CITY OF TACOMA
Public Works Engineering

ADDENDUM NO. 1

REVISIONS TO:
Request for Bids Specification No. TR24-0066F
Annie 1&2 Track Upgrades

TACOMA RAIL
 #9 LH PANDROL TURNOUT
 STANDARD PLAN NO. RAIL-03

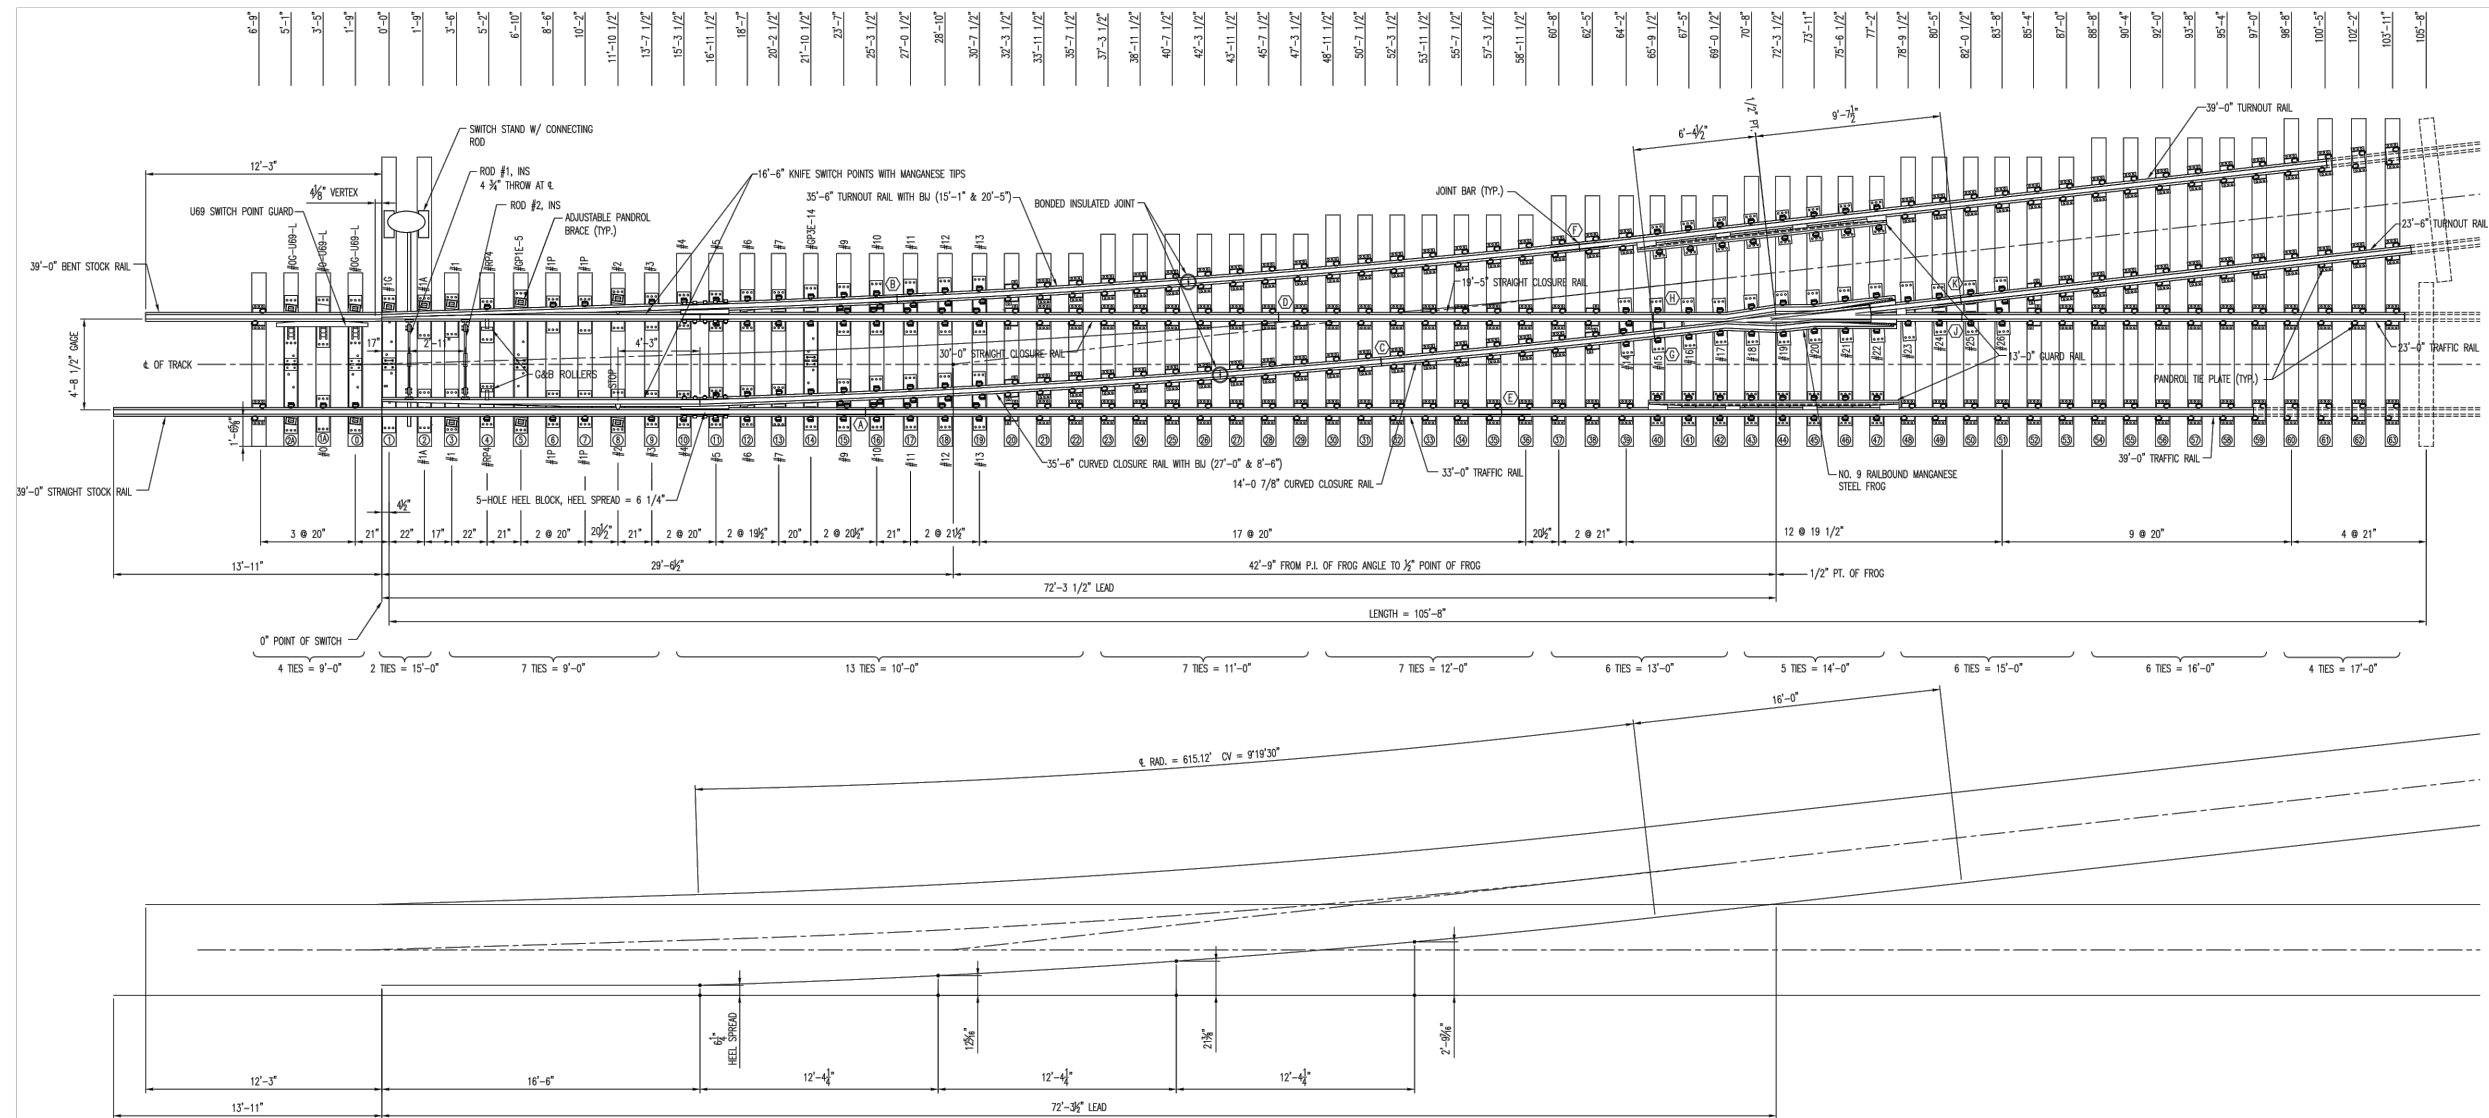
Please provide copies of the applicable Tacoma Rail Standard Plans.

Our turnout supplier is requesting them for additional information, such as the AREMA reference for the frogs.

Plans provided in this addendum.

STANDARD PLAN NO. RAIL-04

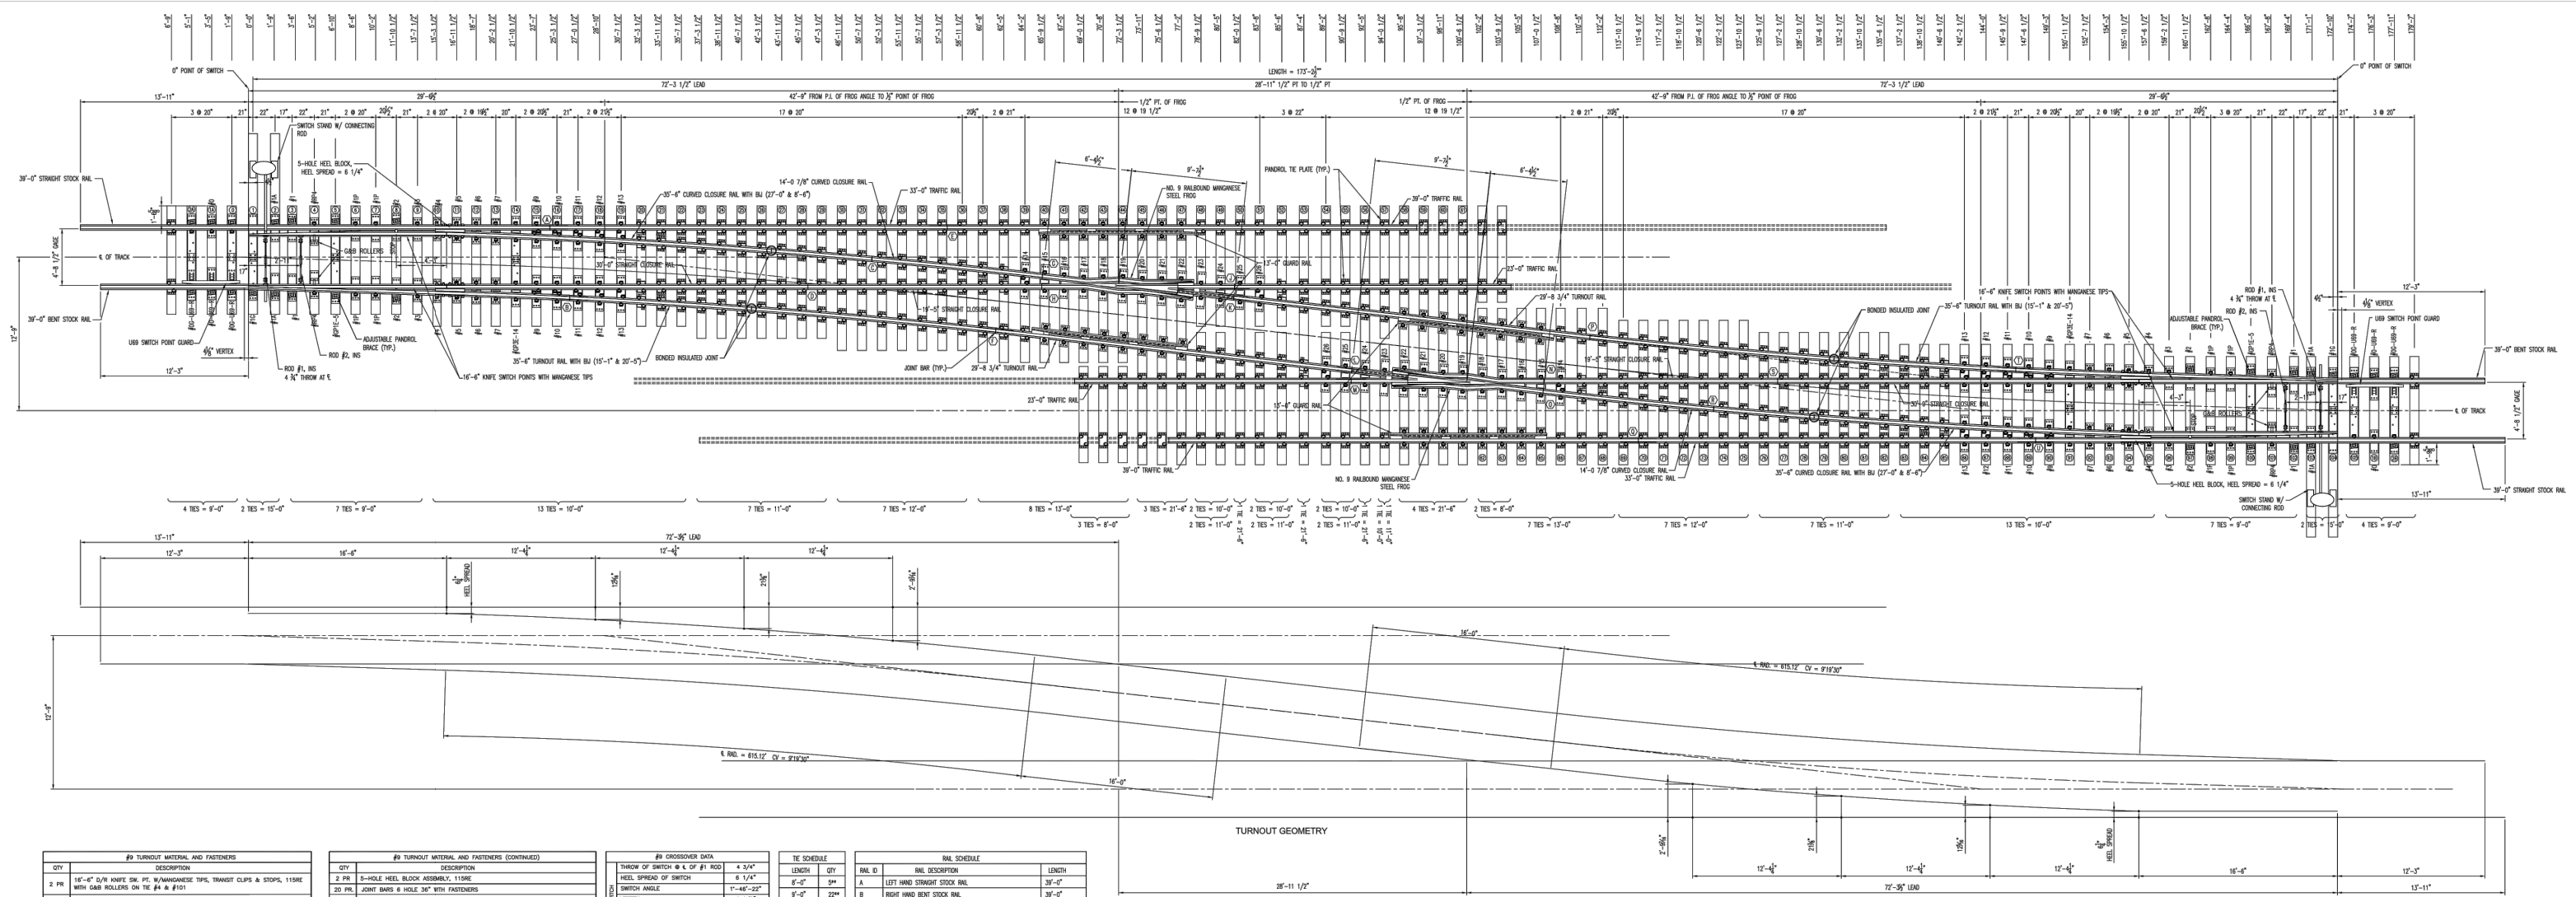
The table on page 91 only shows the track spacing for the crossovers. There is no additional information such as the frog to frog distance or the tie layout etc.

Our turnout supplier is asking if we have any additional information on the crossovers.

We are requesting that Tacoma Rail provide a layout drawing for the crossovers with additional details.

Please refer to our standard crossover plan supplied in this addendum. This will require the supplier to adjust the layout based on track centers given as in past projects. The standard plan also shows two shorter ties where 22' ties would go. We prefer all long wood in those locations.
